**Bid #CA23-2526**  
**WEST VALLEY-MISSION COMMUNITY COLLEGE**  
**DISTRICT**  
**WV STEM CLASSROOM HVAC UPGRADES**

**BID ADDENDUM NO. 1**

**PROJECT:** WEST VALLEY COLLEGE  
WV STEM CLASSROOM HVAC UPGRADES  
14000 Fruitvale Avenue  
Saratoga, CA95070

**ADDENDUM DATE:** May 13<sup>th</sup>, 2026

**M211**

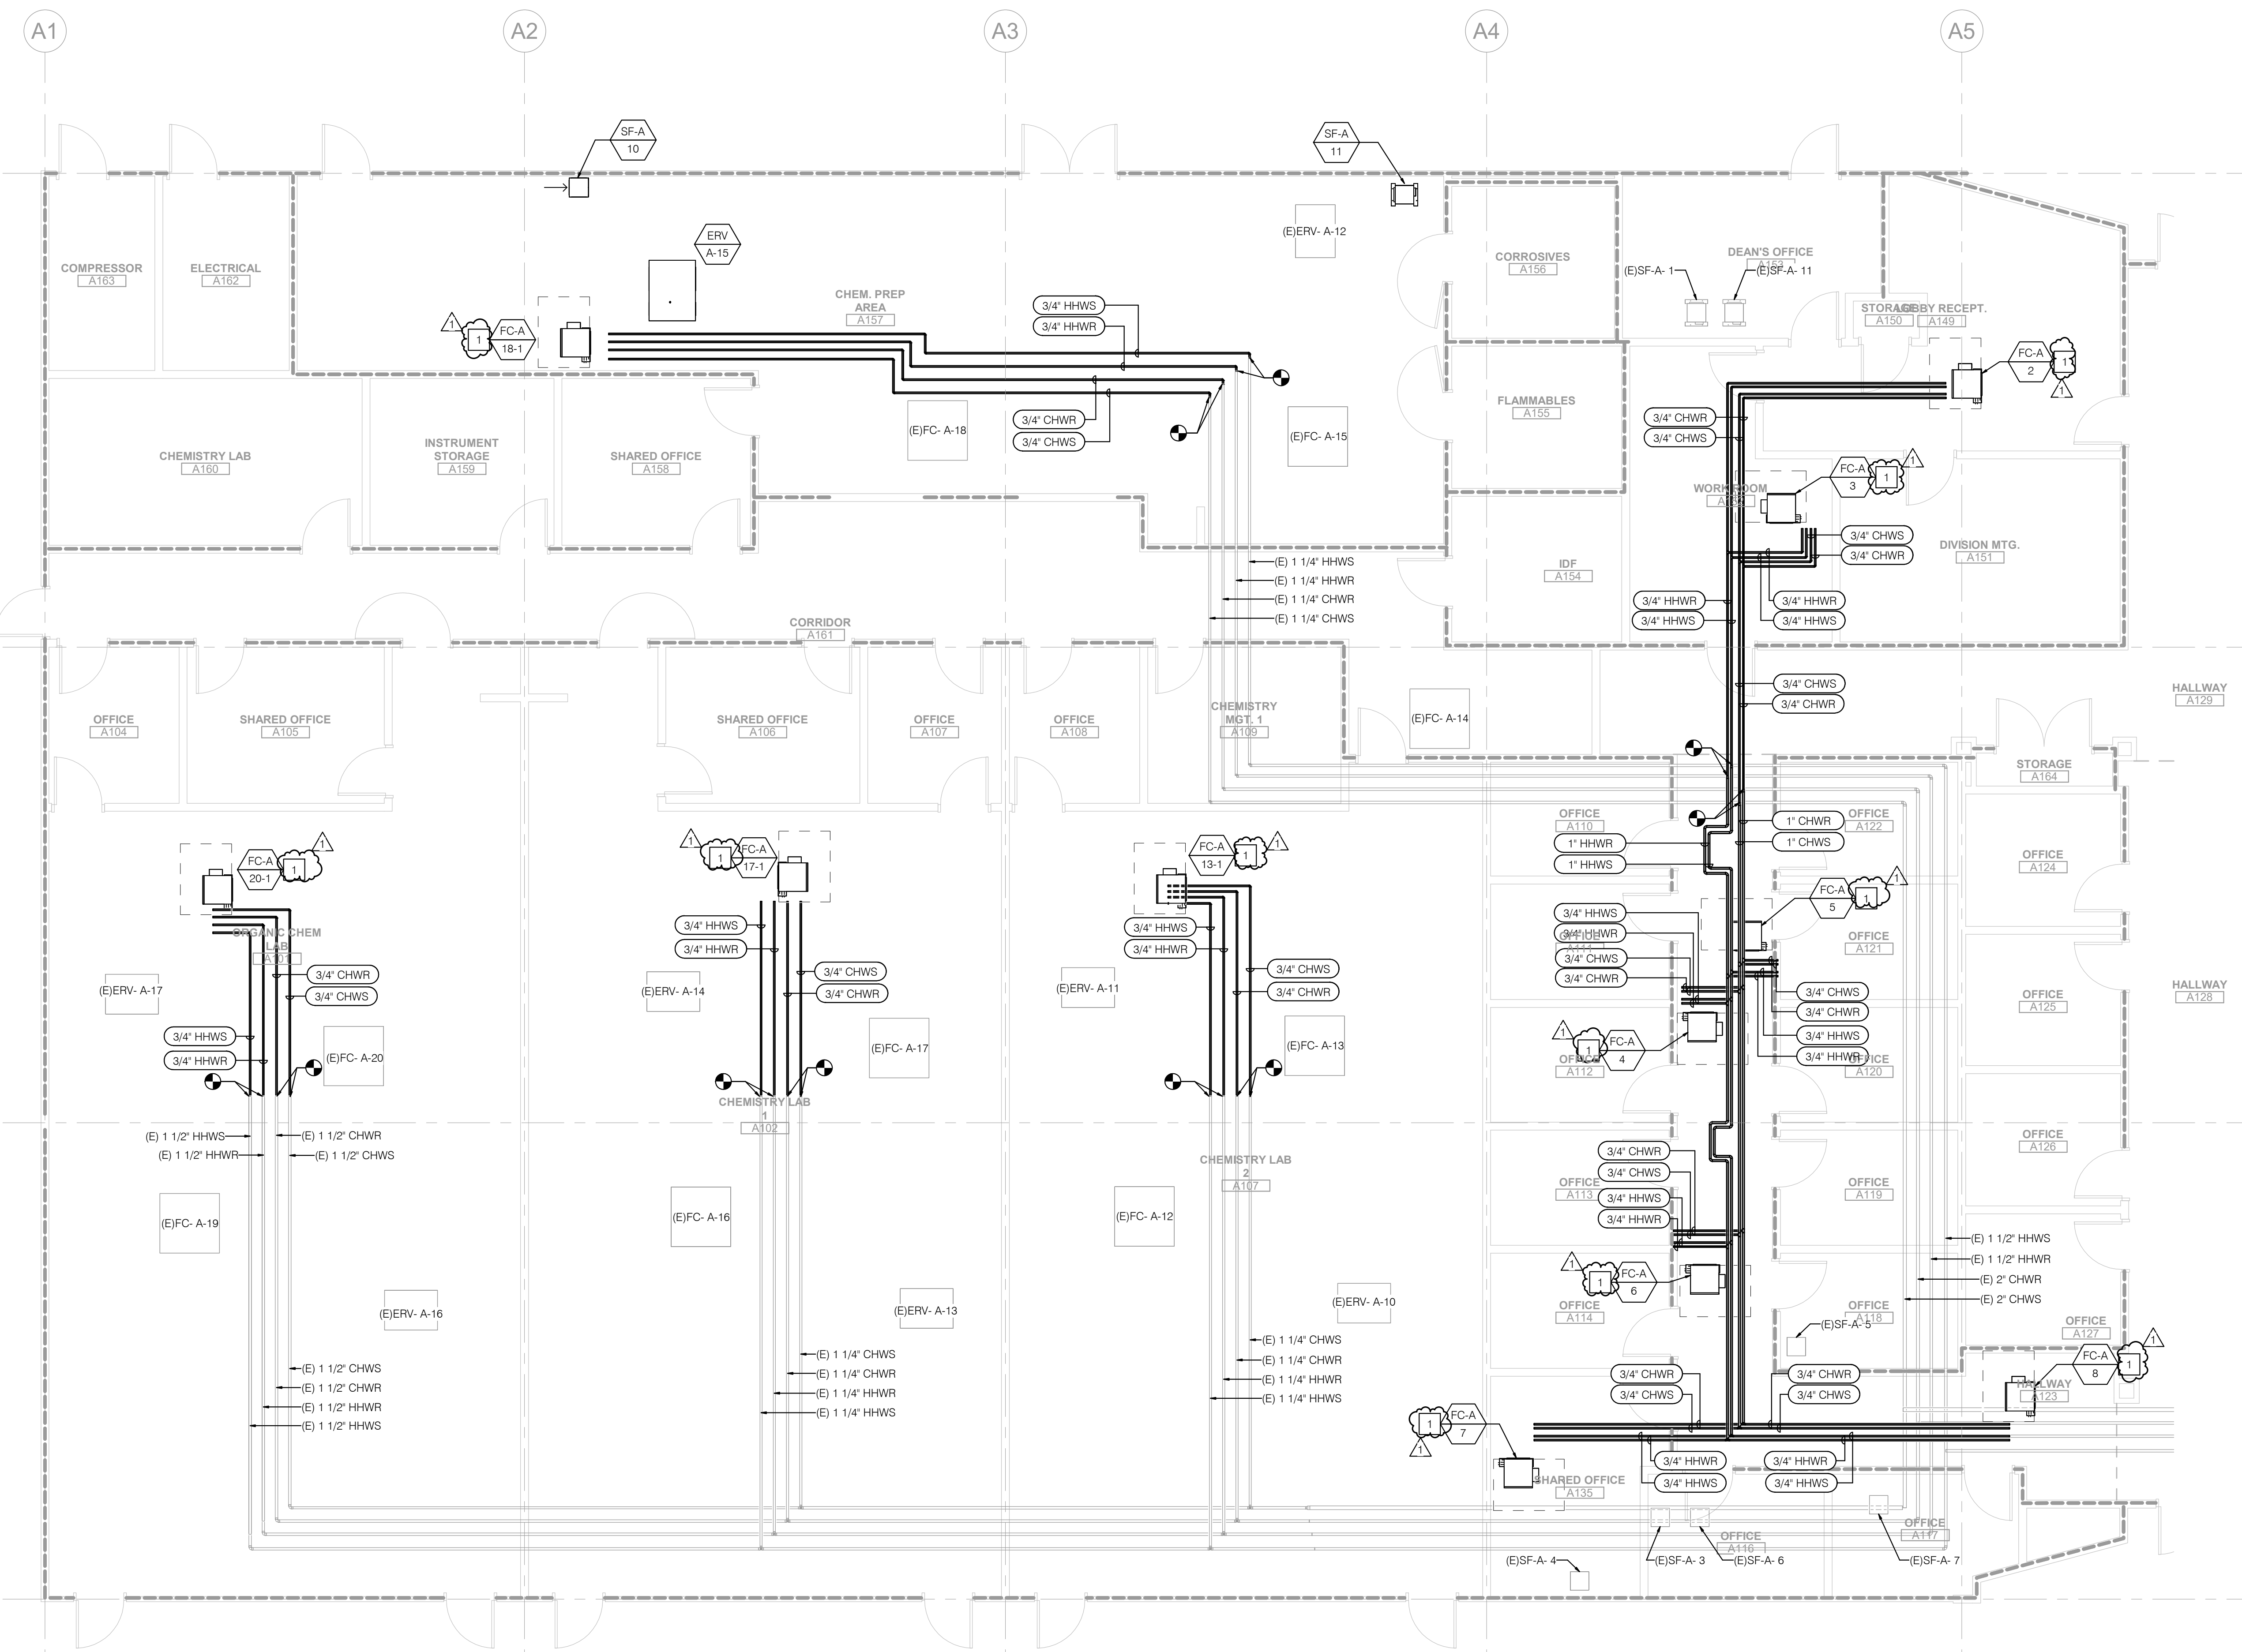
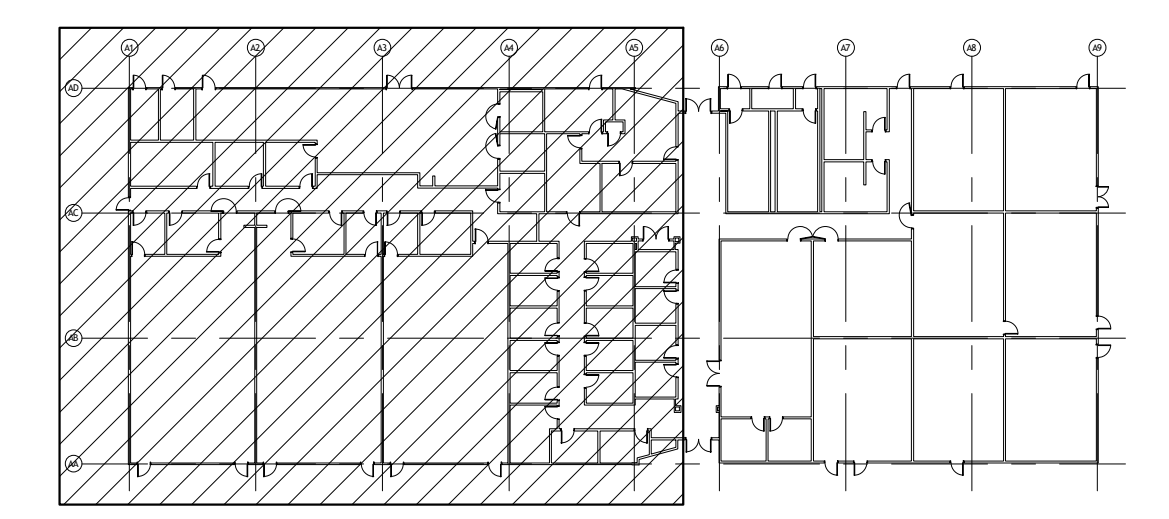
- EXISTING PIPING IS DIAGRAMMATIC AND MODELED FROM RECORD DRAWINGS. CONTRACTOR SHALL MEASURE EXISTING PIPING TO BE DEMOLISHED AND INSTALL PIPING WITH EQUIVALENT DIMENSIONS.

- SEE DETAIL 1/M601 FOR COIL CONNECTION.
- CONTRACTOR SHALL CONNECT PROPOSED FAN COIL CONDENSATE PIPING TO NEAREST EXISTING CONDENSATE PIPE. PROVIDE TRAP DRAIN LINE ACCORDING TO LOCAL CODE.

- SEE DETAIL 4/M601 AND 5/M601 FOR SUSPENDED PIPING SUPPORT.
- CONTRACTOR SHALL INSULATE ALL CHILLED WATER, HEATING HOT WATER, AND CONDENSATE PIPING BEING INSTALLED. REPAIR ANY DAMAGED PIPING AND PIPING INSULATION WITHIN THE SCOPE OF WORK AREA.

- CONTRACTOR SHALL VERIFY AND PROVIDE CONDENSATE LINE OF EXISTING FAN COIL IF NECESSARY. PROPOSED FAN COILS SHALL BE CONNECTED TO NEAREST CONDENSATE LINE.

- PROVIDE AUTOMATIC AIR VENTS AT HIGH POINTS IN THE HEATING HOT WATER AND CHILLED WATER SYSTEM. AIR VENTS SHALL BE CONNECTED TO NEAREST SINK DRAIN LINE.

- PROVIDE CONDENSATE LINE FOR FAN COIL. ROUTE TO NEAREST EXISTING CONDENSATE DRAIN LINE.
